DHCD, DBFR 2009 Code Change Process

April 8, 2010 Meeting Agenda Package

Workgroup 2 -USBC/SFPC Technical Amendments

USBC: VCC

FIGURE R602.10.6.1
METHOD ABW: ALTERNATE BRACED WALL PANEL

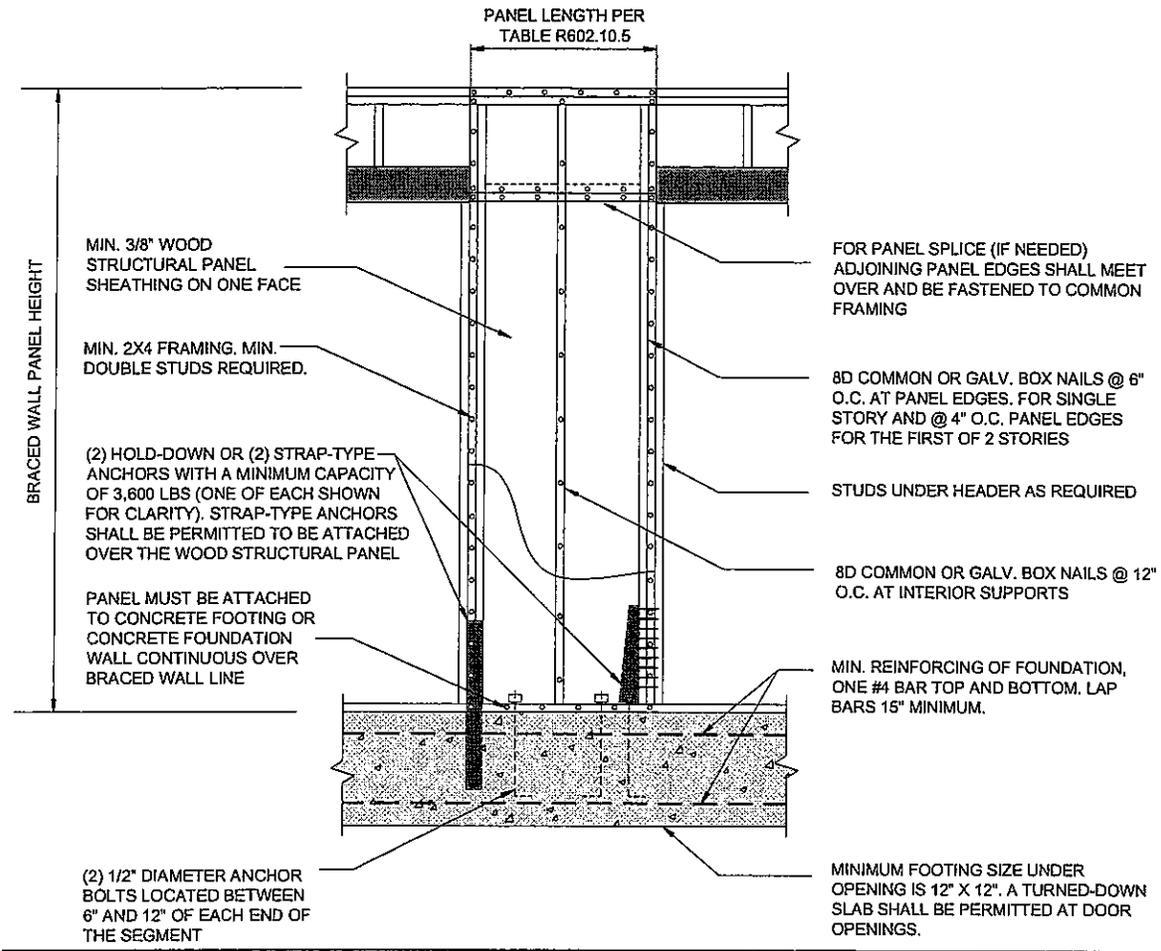
R602.10.6.1 Method ABW: Alternate braced wall panels. Method ABW braced wall panels shall be constructed in accordance with Figure R602.10.6.1.

FIGURE R602.10.6.2
METHOD PFH: PORTAL FRAME WITH HOLD-DOWNS

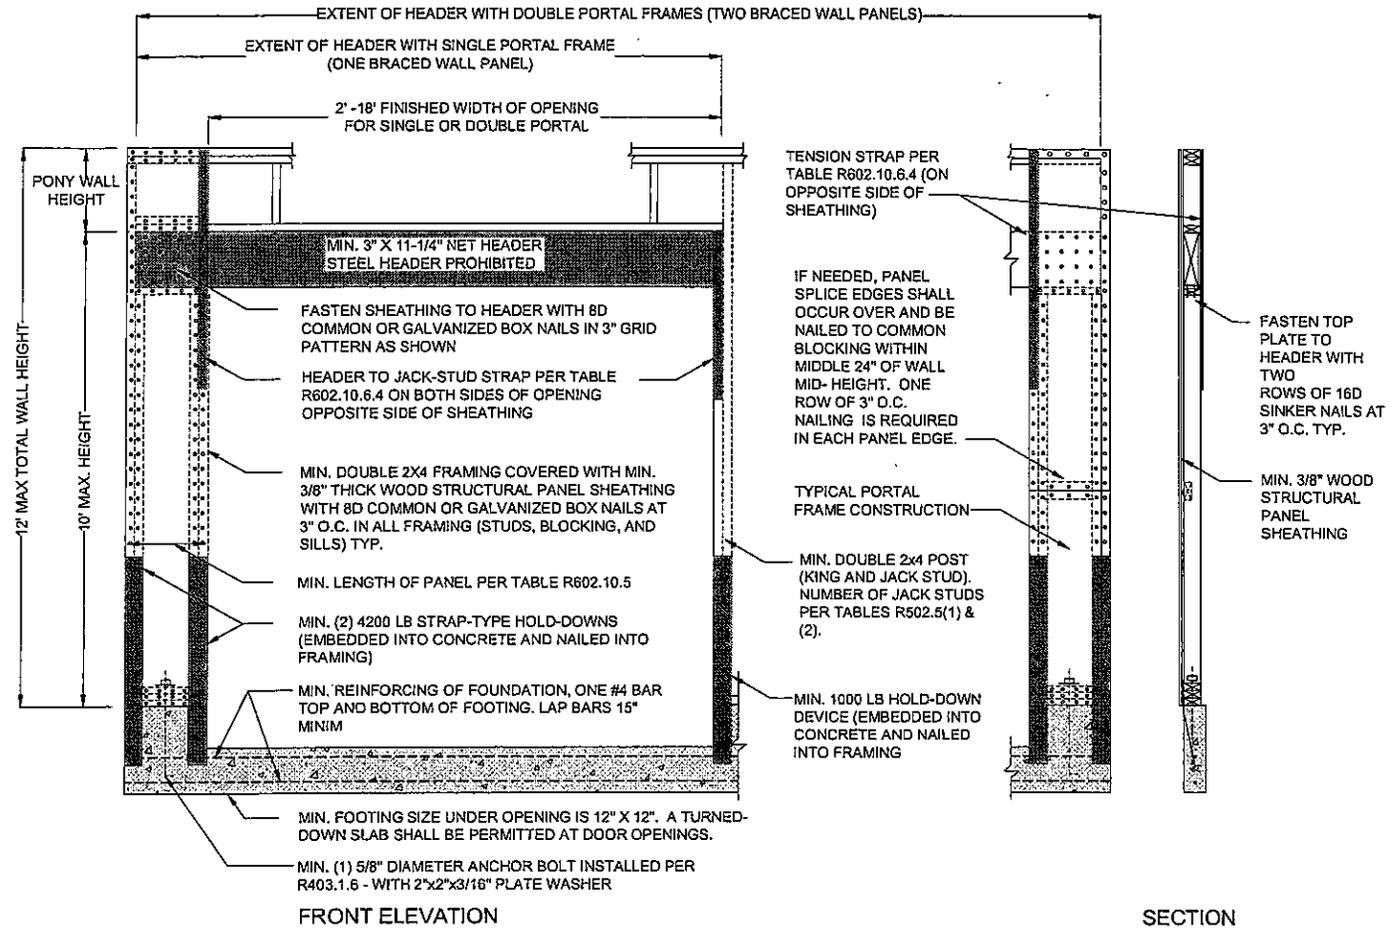
R602.10.6.2 Method PFH: Portal frame with hold-downs. Method PFH braced wall panels shall be constructed in accordance with Figure R602.10.6.2.

FIGURE R602.10.6.3
METHOD PFG: PORTAL FRAME AT GARAGE DOOR OPENINGS
IN SEISMIC DESIGN CATEGORIES A, B AND C

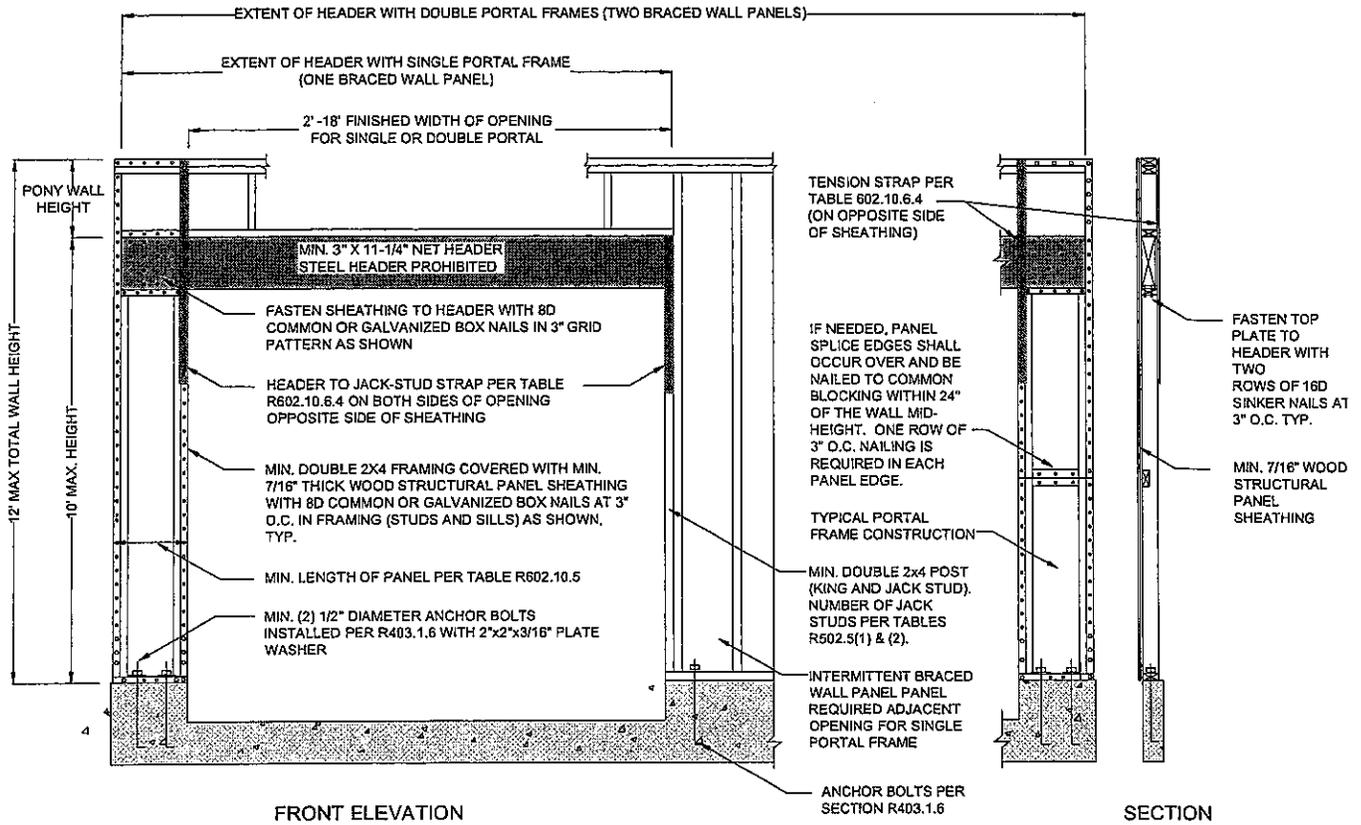
R602.10.6.3 Method PFG: Portal frame at garage door openings. Where supporting a roof or one story and a roof, a Method PFG braced wall panel constructed in accordance with Figure R602.10.6.3 shall be permitted on either side of garage door openings.

FIGURE R602.10.6.4
METHOD CS-PF: CONTINUOUSLY SHEATHED PORTAL FRAME PANEL CONSTRUCTION

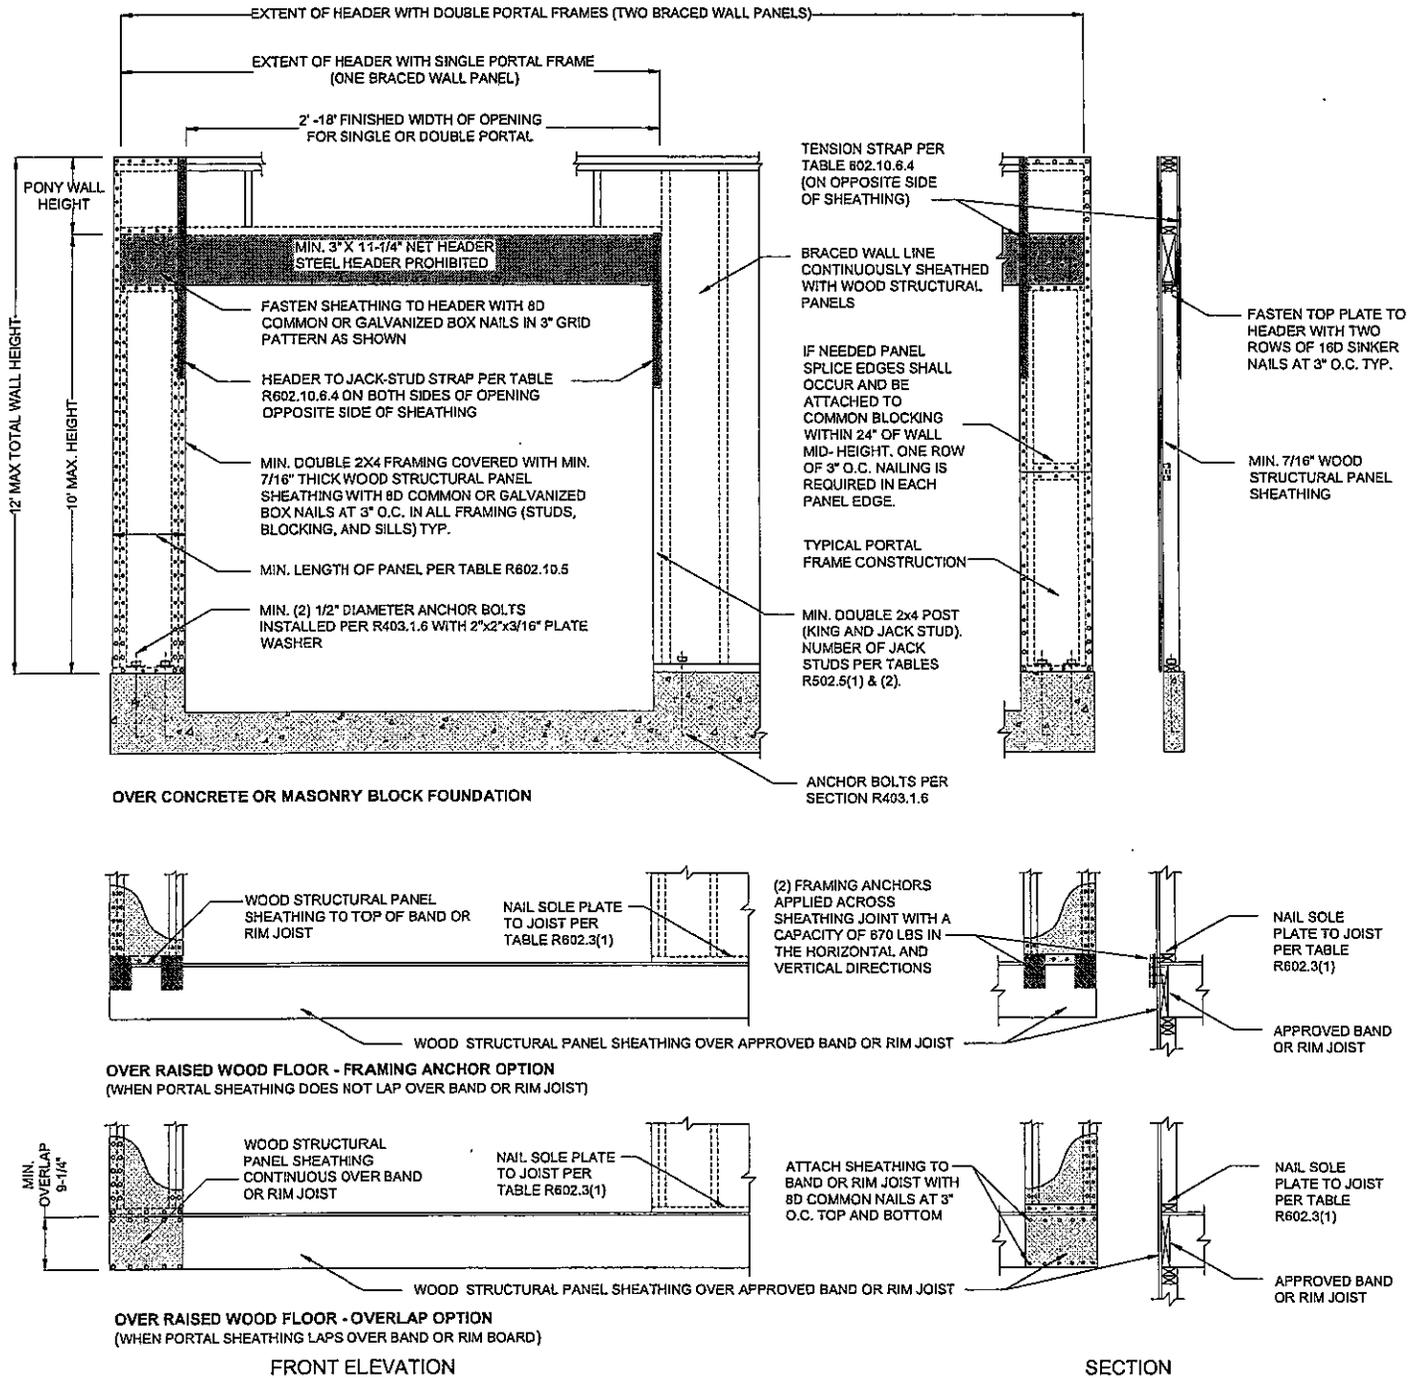
R602.10.6.4 Method CS-PF: Continuously sheathed portal frame. Continuously sheathed portal frame braced wall panels shall be constructed in accordance with Figure R602.10.6.4 and Table R602.10.6.4. The number of continuously sheathed portal frame panels in a single braced wall line shall not exceed four.

FIGURE R602.10.7
END CONDITIONS FOR BRACED WALL LINES WITH CONTINUOUS SHEATHING

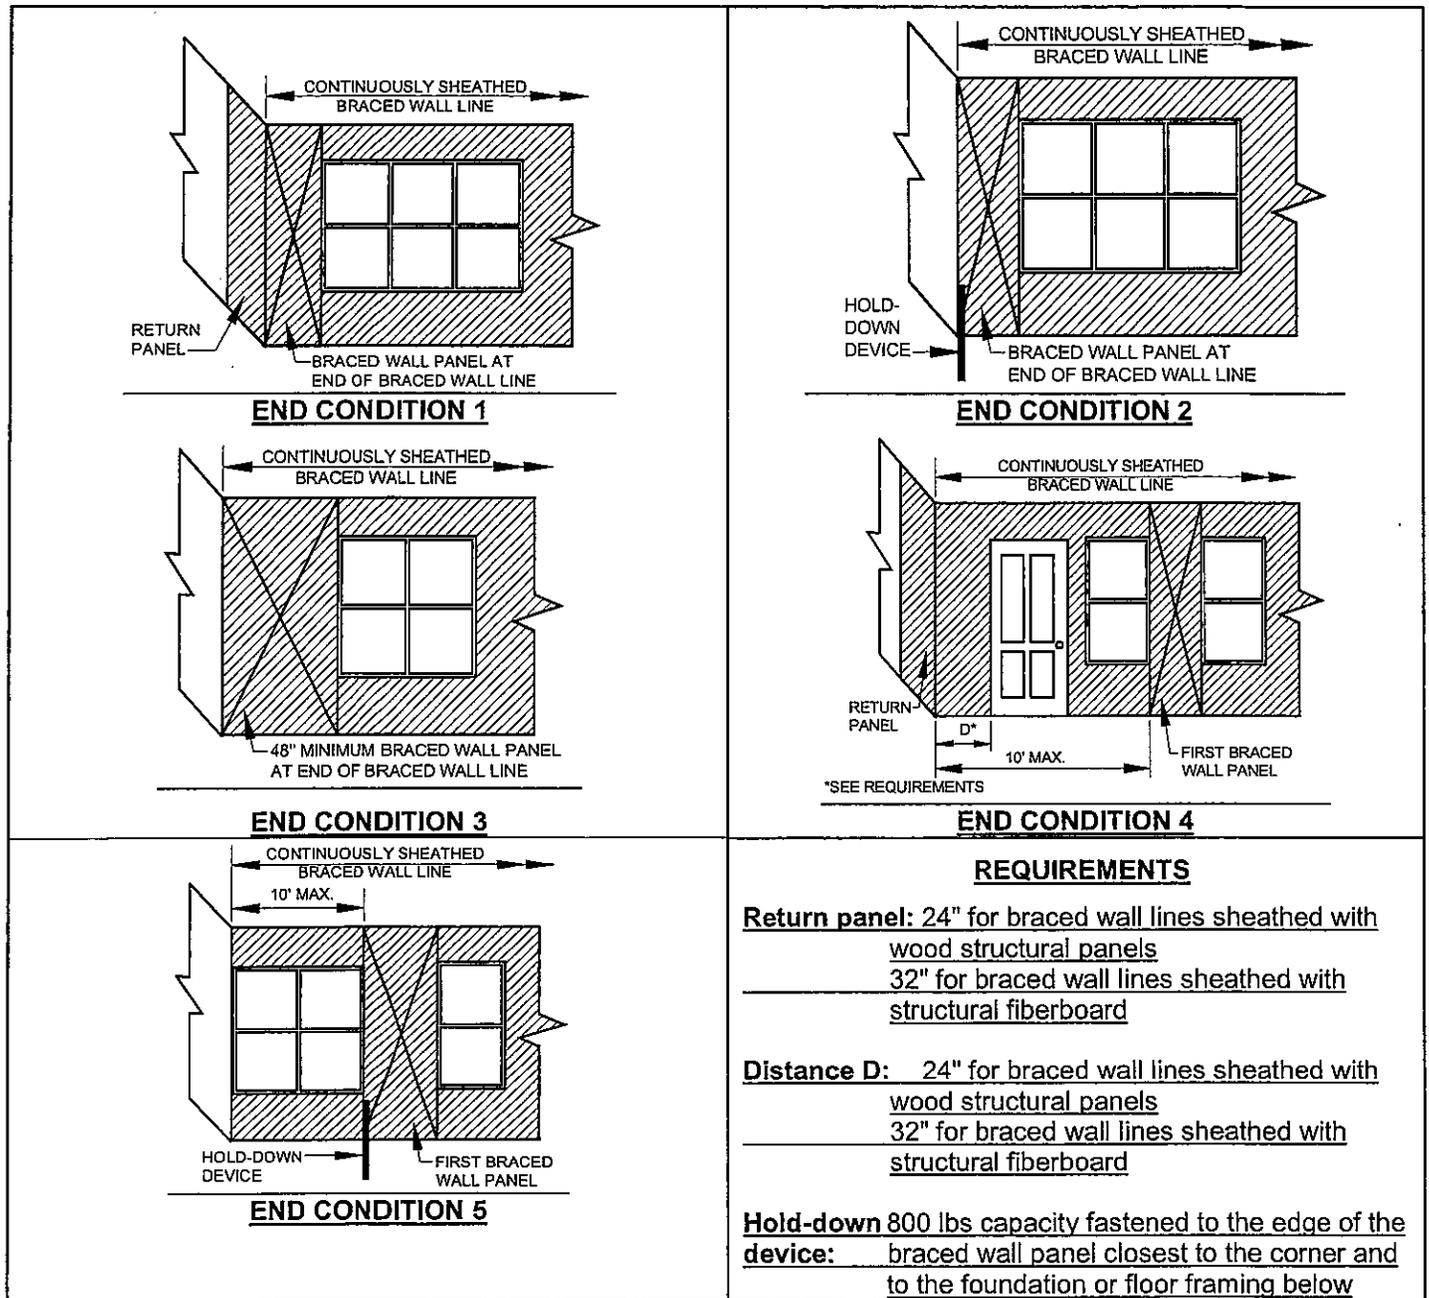
R602.10.7 Ends of braced wall lines with continuous sheathing. Each end of a braced wall line with continuous sheathing shall be in accordance with one of the end conditions shown in Figure R602.10.7.

FIGURE R602.10.9
MASONRY STEM WALLS SUPPORTING BRACED WALL PANELS

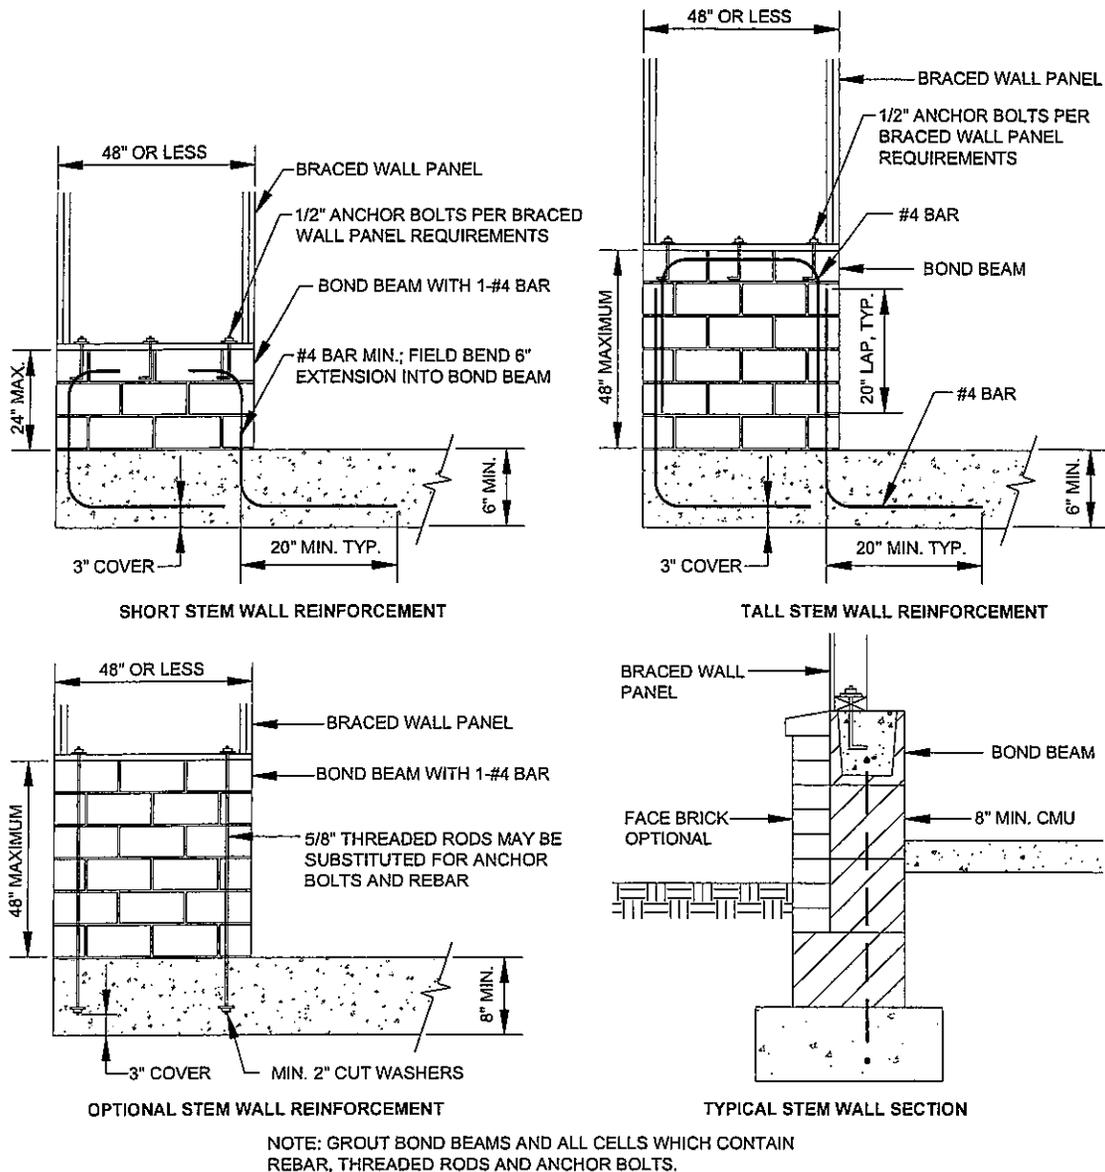
1. Cantilevered floor joists complying with Section R502.3.3 shall be permitted to support braced wall panels.
2. Elevated post or pier foundations supporting braced wall panels shall be designed in accordance with accepted engineering practice.
3. Masonry stem walls with a length of 48 inches (1220 mm) or less supporting braced wall panels shall be reinforced in accordance with Figure R602.10.9. Masonry stem walls with a length greater than 48 inches (1220 mm) supporting braced wall panels shall be constructed in accordance with Section R403.1. Methods ABW and PFH shall not be permitted to attach to masonry stem walls.
4. Concrete stem walls with a length of 48 inches (1220 mm) or less, greater than 12 inches (305 mm) tall and less than 6 inches (152 mm) thick shall have reinforcement sized and located in accordance with Figure R602.10.9.

FIGURE R602.12.1
RECTANGLE CIRCUMSCRIBING AN ENCLOSED BUILDING

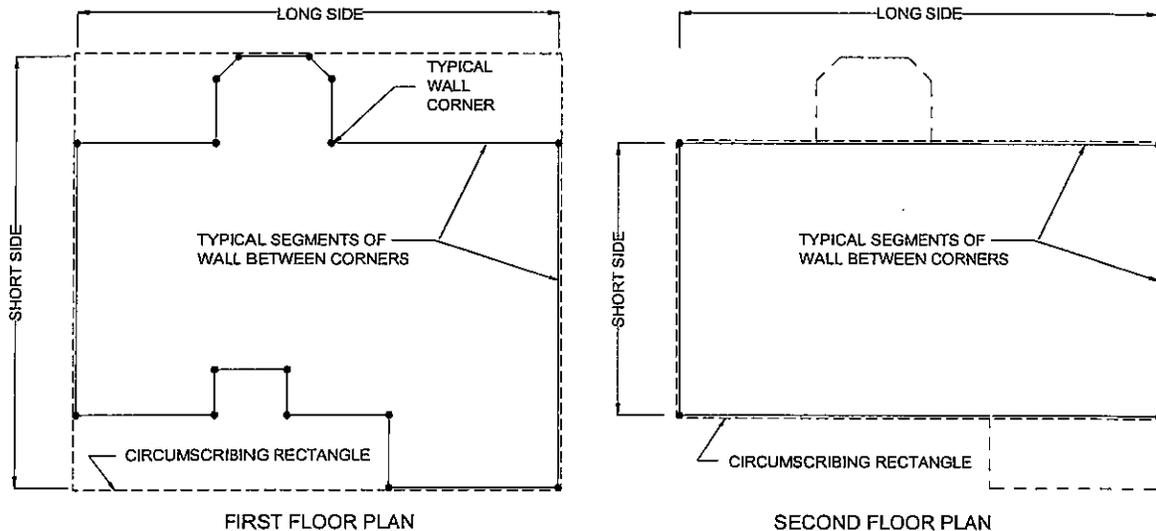
R602.12.1 Circumscribed rectangle. Required bracing shall be determined by circumscribing a rectangle around the entire building on each floor as shown in Figure R602.12.1. The rectangle shall surround all enclosed offsets and projections such as sunrooms and attached garages. Open structures, such as carports and decks shall be permitted to be excluded. The rectangle shall have no side greater than 60 feet (18 288 mm), and the ratio between the long side and short side shall be a maximum of 3:1.

FIGURE R602.12.5
BRACING UNIT DISTRIBUTION

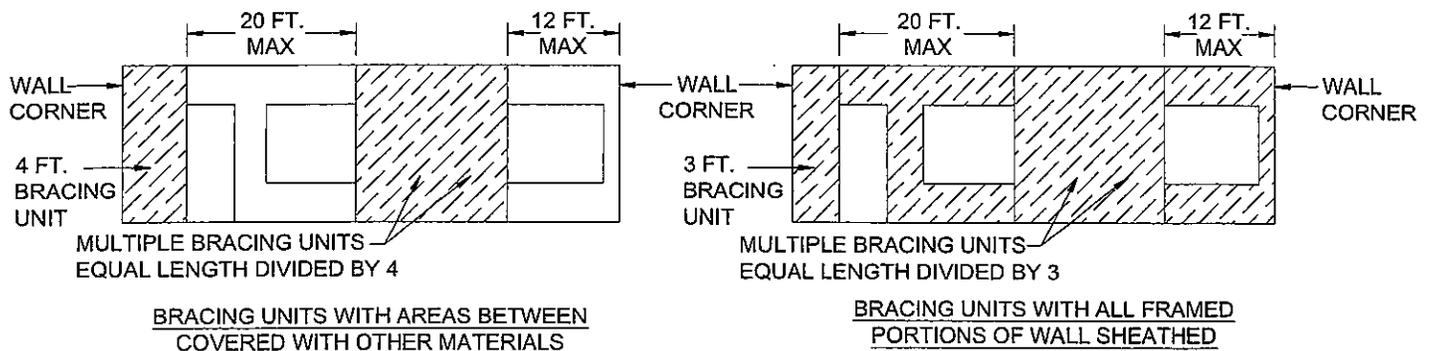
R602.12.5 Distribution of bracing units. The placement of bracing units on exterior walls shall meet all of the following requirements as shown in Figure R602.12.5.
